## Standards Update Transmittal

Reference Number: 2024-14  
Standards: Standard Construction Specifications, Section 38  
Improvement Standards, Section 9-11, 9-12, 9-24, 9-25  
**Update:** Standard Drawings, ST-10 & SD-23

DRAWING NUMBER  
**ST - 10**

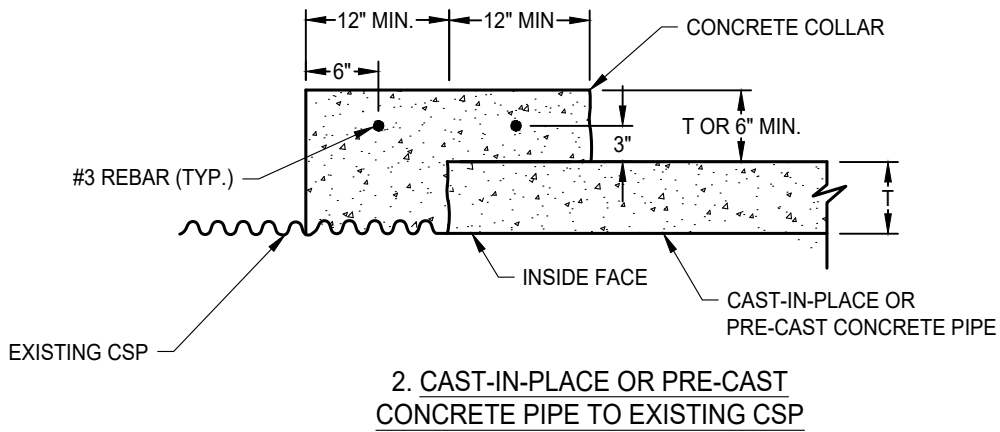
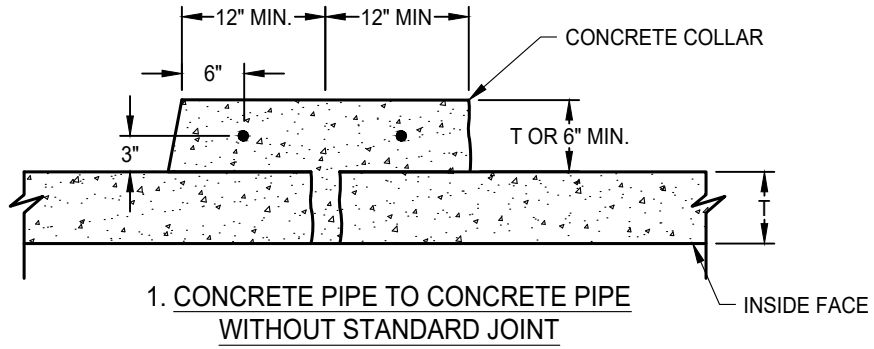
- a. Standard Drawing ST-10 was edited to show bedding under the pipe and clarify the excavation backfill areas.
- b. Standard Drawing SD-23 deletes details that included metal pipe.
- 4. Modifications are as follows:
  - a. Standard Drawings SD-20, SD-21.1, SD-21.2 and SD-22 are being deleted because metal pipe is no longer allowed within the City limits.
